SUBJECT: Forwards response to requests for addl info re license
renewal for Oconee Nuclear Station, Units 1, 2 & 3. Util
responses provided in six attachments to ltr. Attachment 1

Subject: License Renewal
Response to Requests for Additional Information
Oconee Nuclear Station
Docket Nos. 50-269, -270, -287

*Attachment 2A
Oconee Nuclear Station
Application for Renewed Operating Licenses
Responses to NRC Requests for Additional Information*

Figure 3.1-1 Rev. 0 Keowee - Oconee AC Power Flowpath

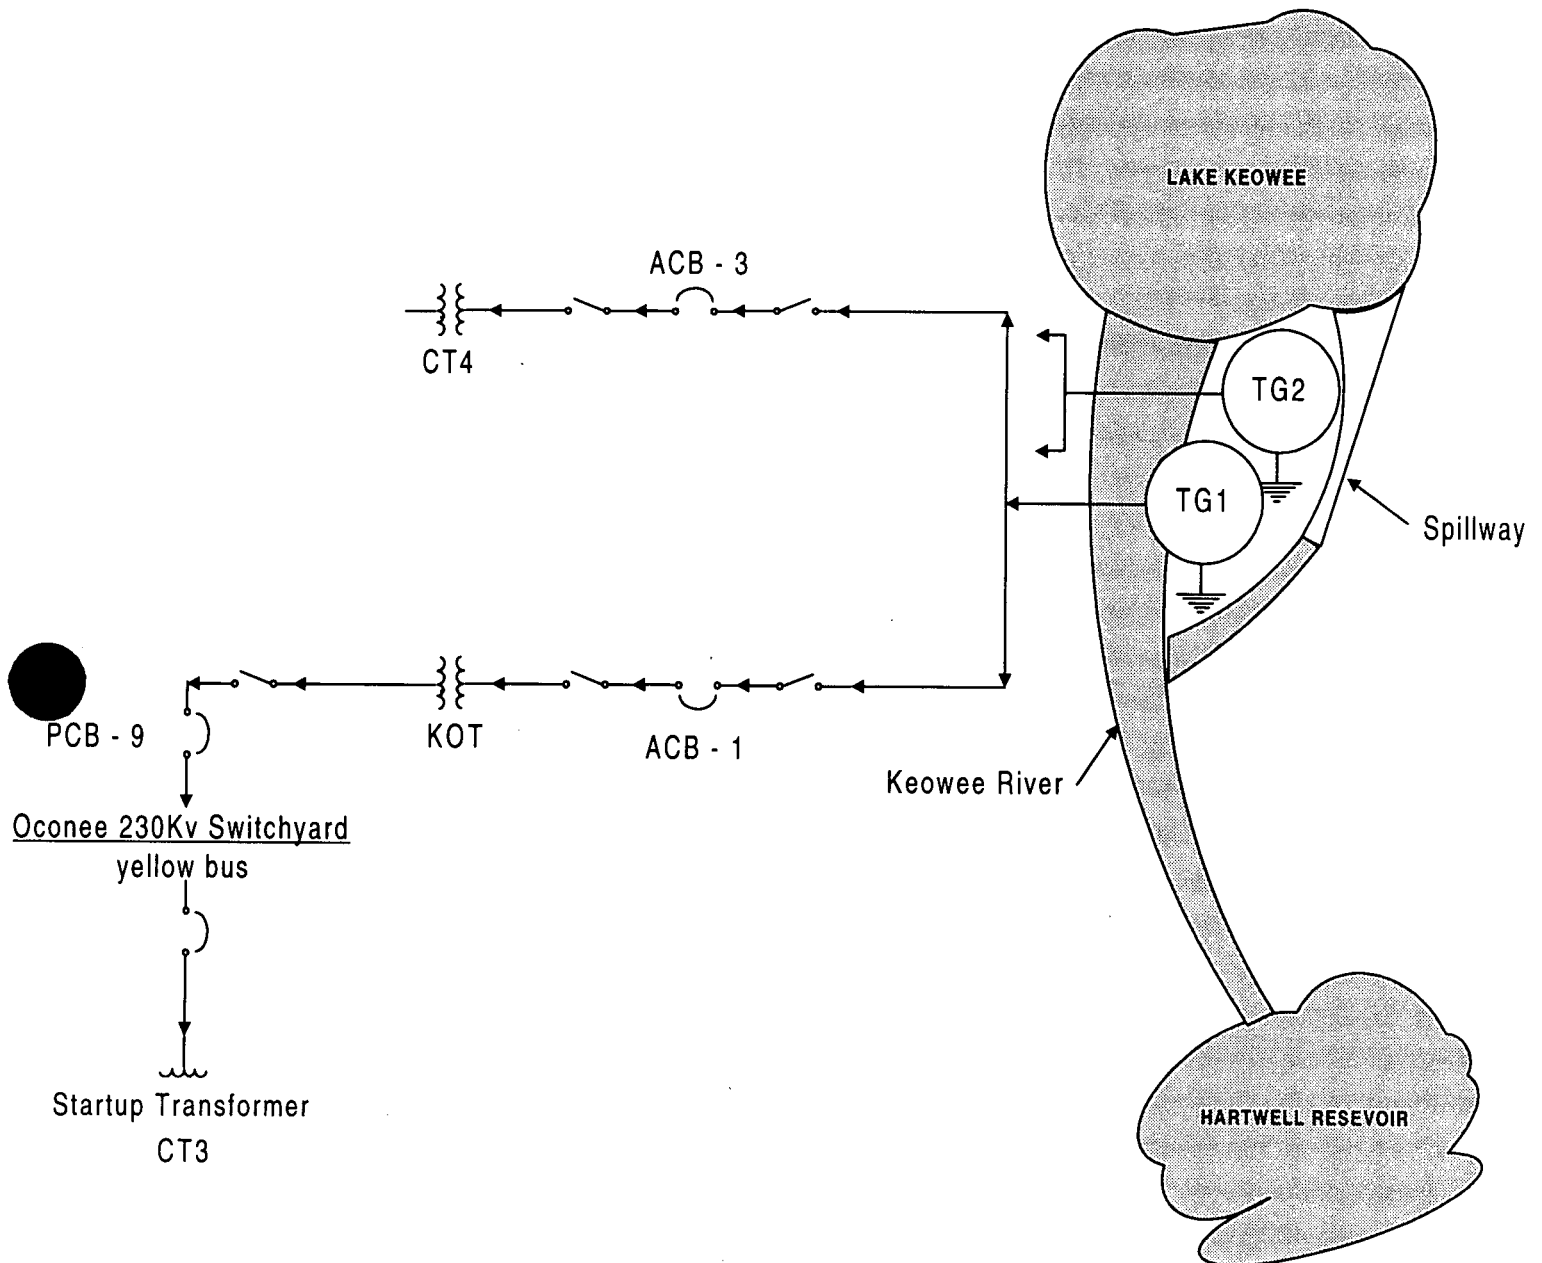
Figure 3.1-1 shows a simplified flow path for ac power from the Keowee hydroelectric generators to the Oconee ac power system.

Figure 3.1-2 Rev. 0 Keowee Subsystems Needed For Oconee AC Power

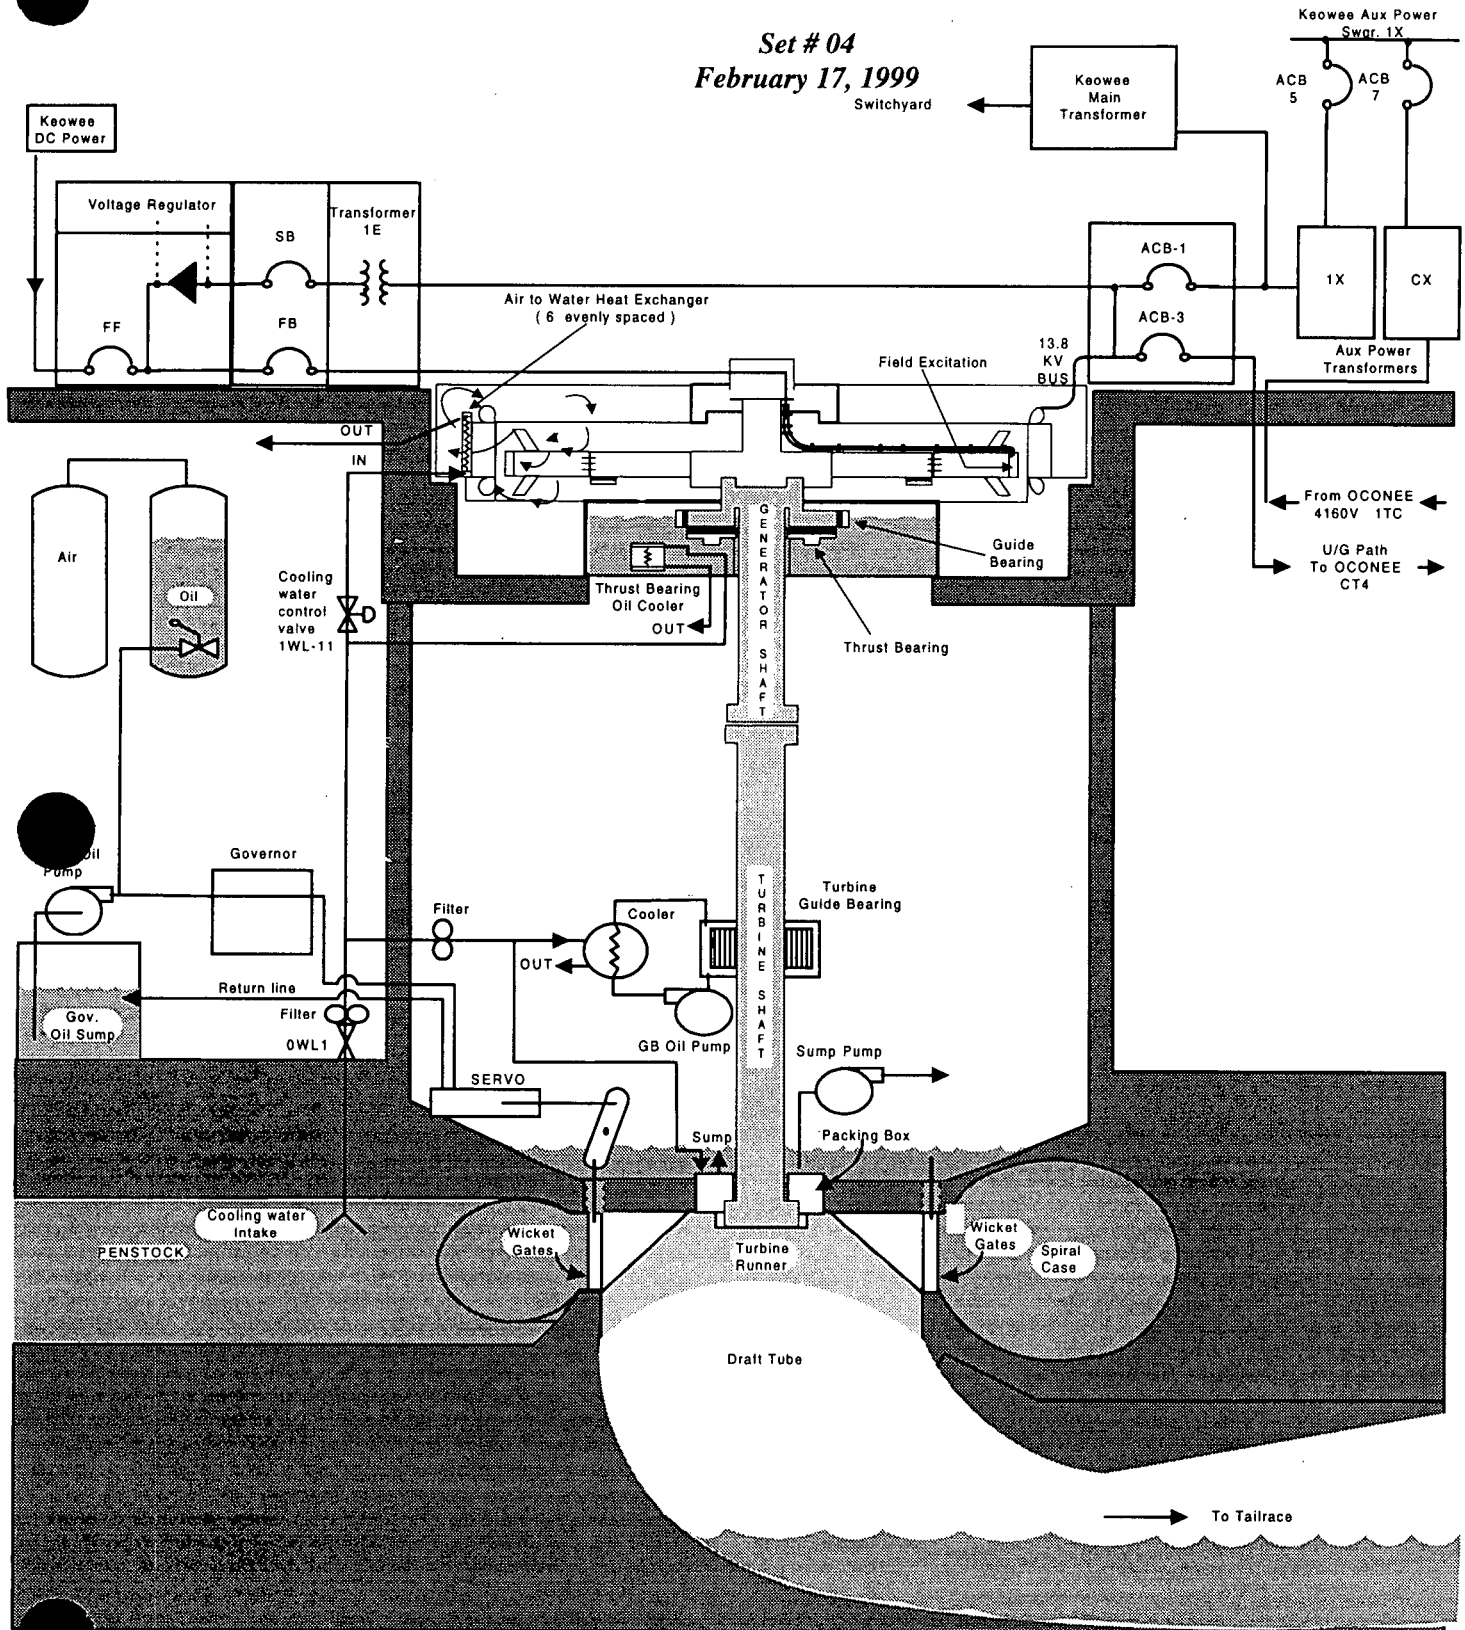
The turbine system consists of (1) the rotating elements (turbine runner and the main turbine shaft), (2) the wicket gate assembly, (3) the packing and bearing assembly, (4) the draft tube assembly, and (5) the sump. (See Figure 3.1-2.)
